DEVIATION REQUEST AND DECISION FORM

Project Name : Trails at Aspen Ridge Filing No. 4
 Schedule No.(s) : 5509305003
 Legal Description : Unplatted Land

WINNER CREEK DRIVE EAST PEDESTRIAN RAMPS
 TRAILS AT ASPEN RIDGE FILING NO. 4 DEVIATION EXHIBIT
 AUGUST 2021

WINNER CREEK DRIVE WEST PEDESTRIAN RAMPS
 TRAILS AT ASPEN RIDGE FILING NO. 4 DEVIATION EXHIBIT
 AUGUST 2021

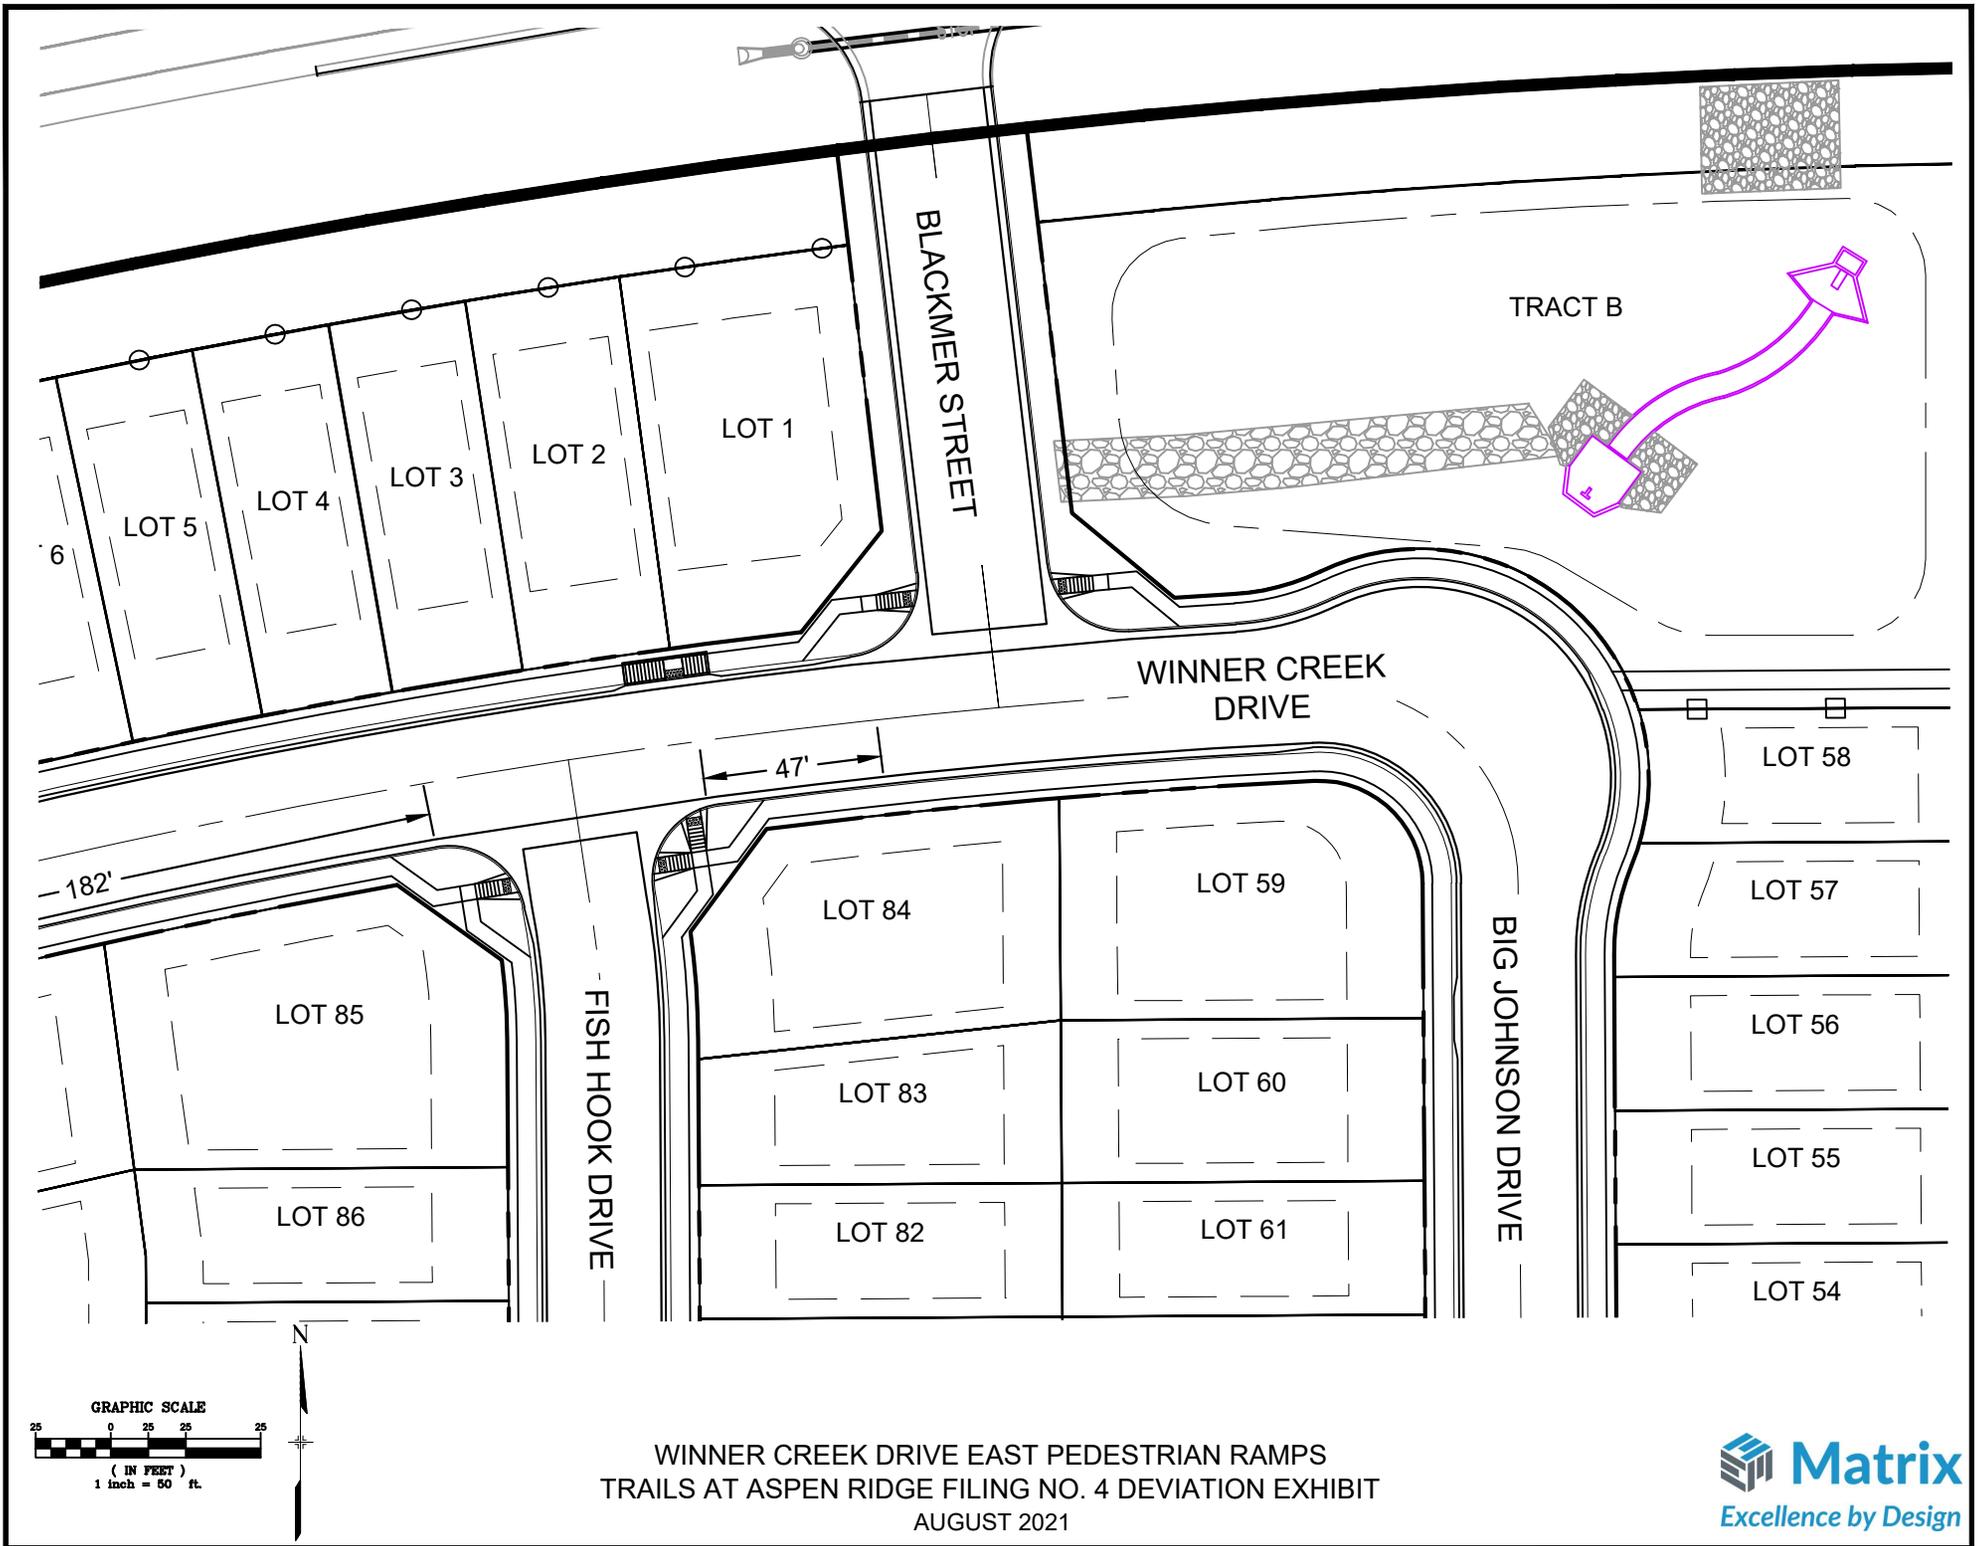
For the "T" intersection at Winner Creek Drive & Keyhole Drive, the lot layout on the north side of Winner Creek Drive prevents a pedestrian crossing perpendicular to the two landings on the south side of Winner Creek Drive. The proposed alternative is a midblock crossing 55' to the west of the intersection that better suits the proposed lot layout and driveway configuration.

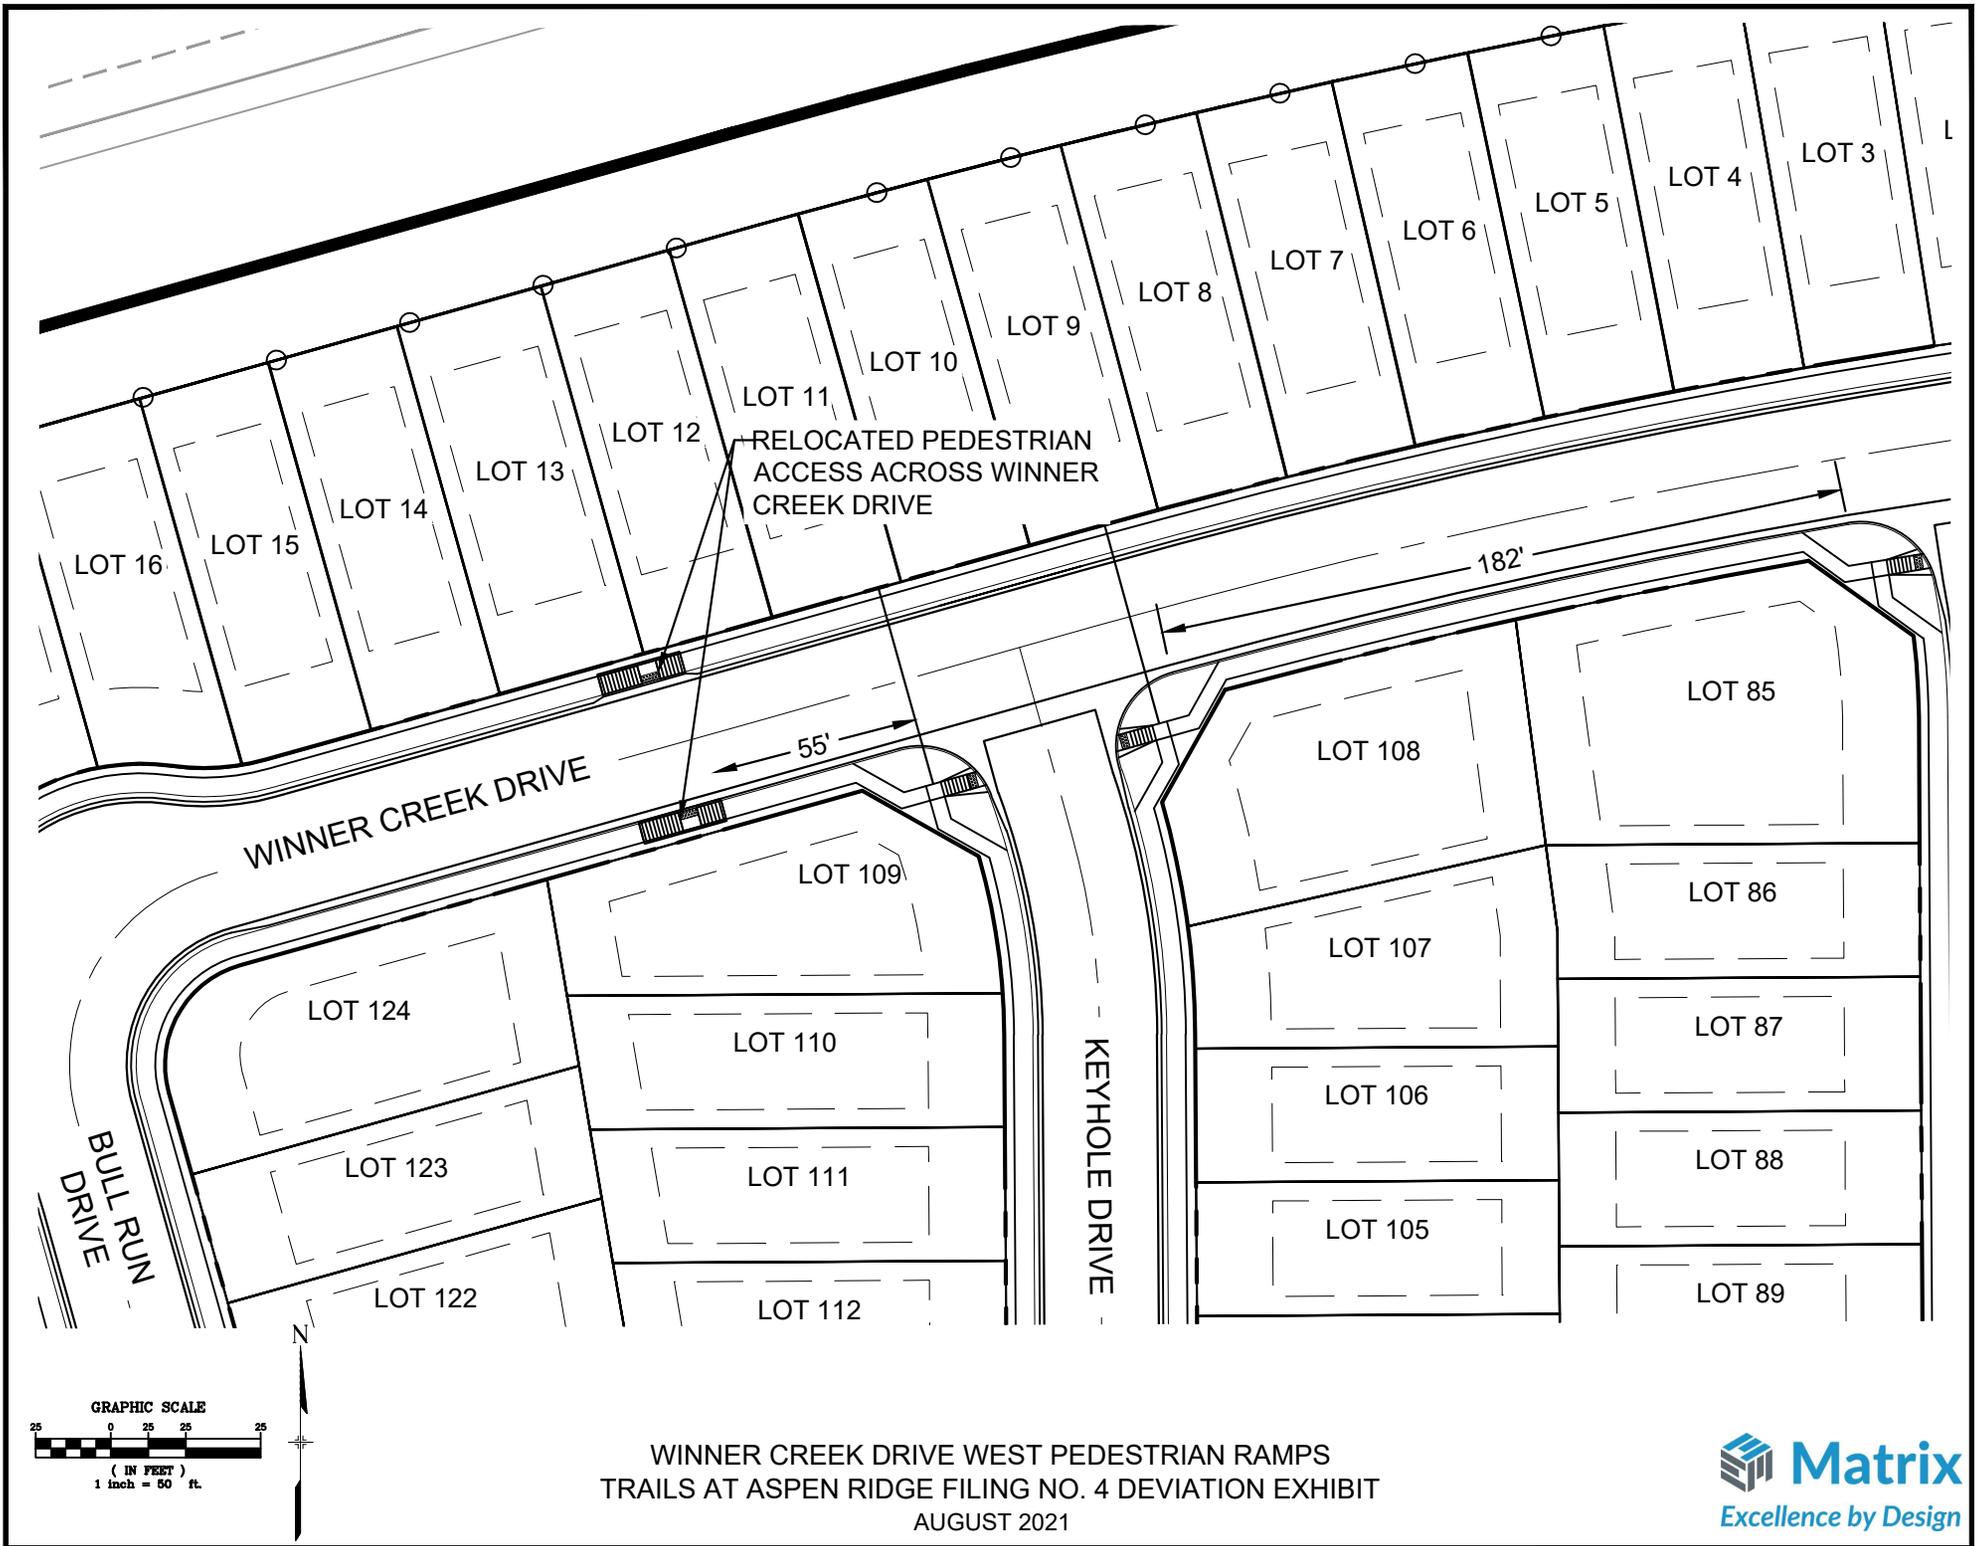
For the "T" intersections at Fish Hook Drive & Winner Creek Drive and Blackmer Street & Winner Creek Drive, the intersection spacing between them is only 47'. Only one pedestrian crossing across Winner Creek Drive is proposed to serve both of these intersections.
